**ADDENDUM #2**  
**EAST INTERCEPTOR SANITARY SEWER OVERFLOW STORAGE FACILITY – PHASE 3**  
**CITY OF DULUTH**  
**PROJECT 0891SN**  
**BID NUMBER 10-0299**  
**JUNE 17, 2010**

**NOTICE**

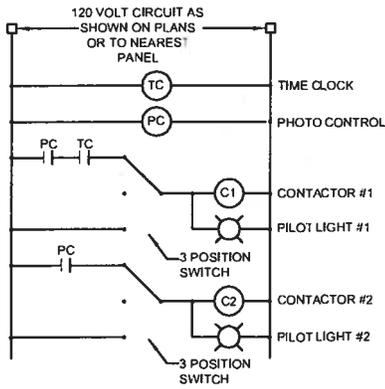
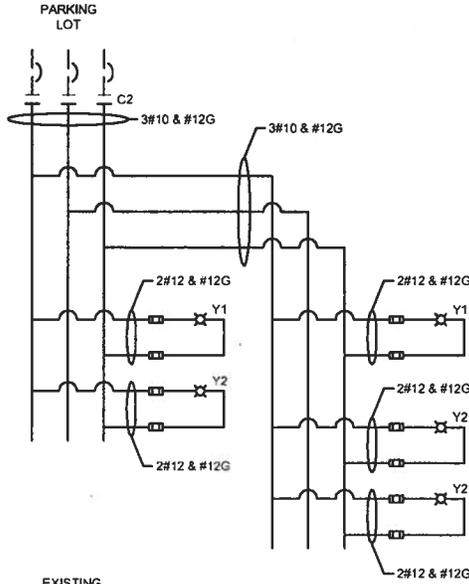
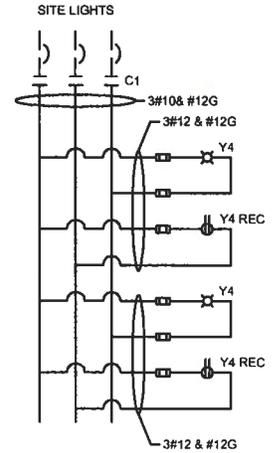
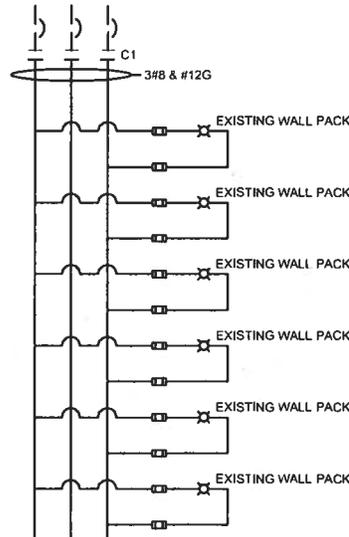
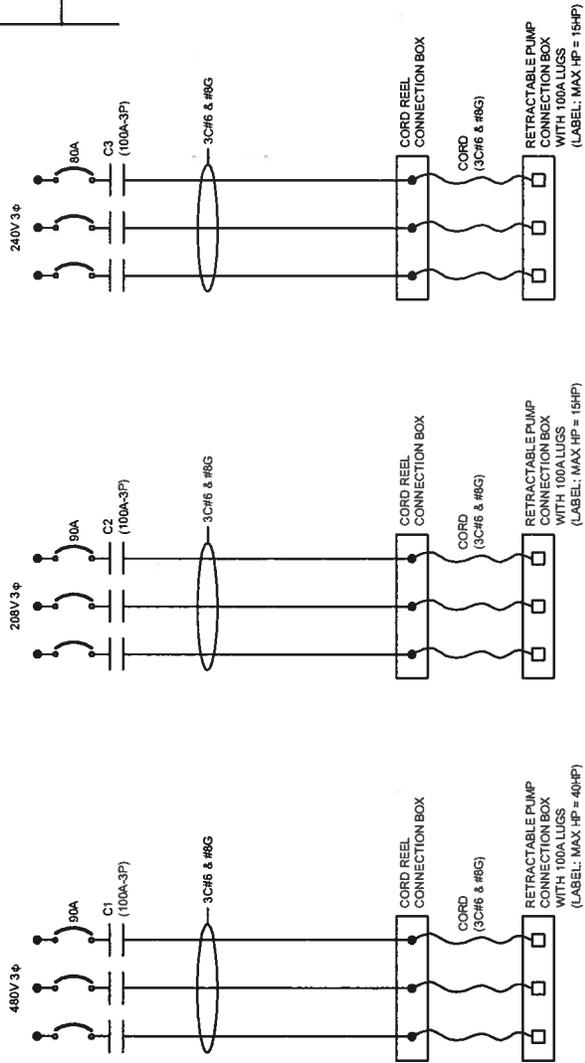
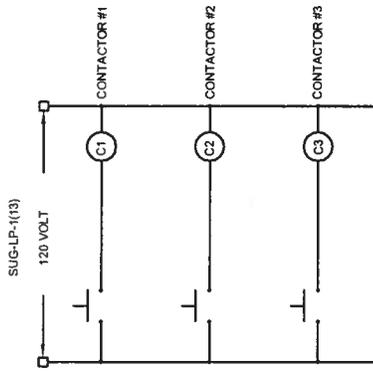
**CLARIFICATION** All heavy line weight conduit runs to site lighting are new, direct buried, and sized by contractor to carry the wiring shown on the revised detail 26 14 10 attached to this addendum.

- REPLACE** Replace Detail 26 14 10 in it's entirety with the attached “Detail 26 14 10”.

**CORD REEL CONTACTOR WIRING DETAIL**

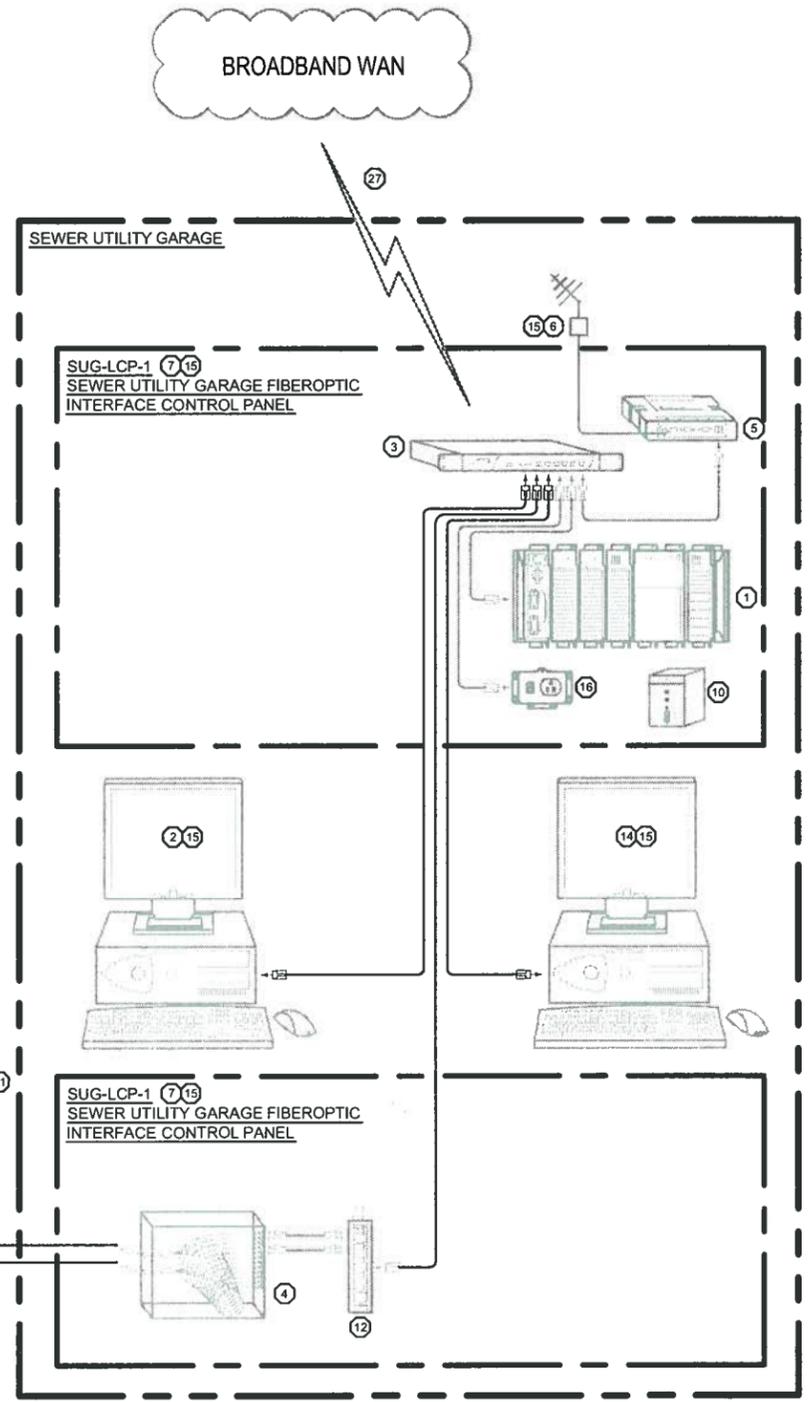
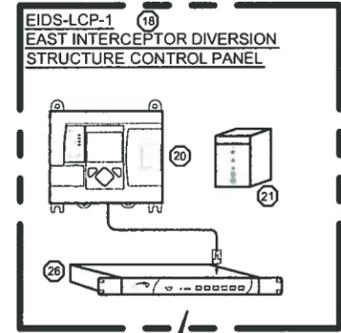
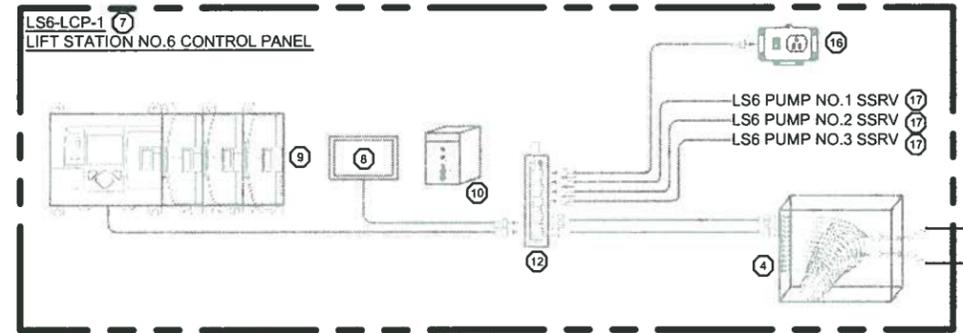
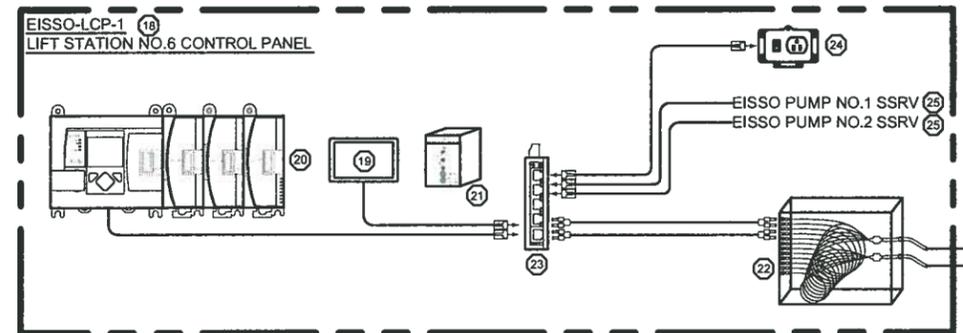
- REPLACE** Replace “Cord Reel Contactor Wiring Detail” in it's entirety with the attached “Cord Reel Contactor Wiring Detail”.
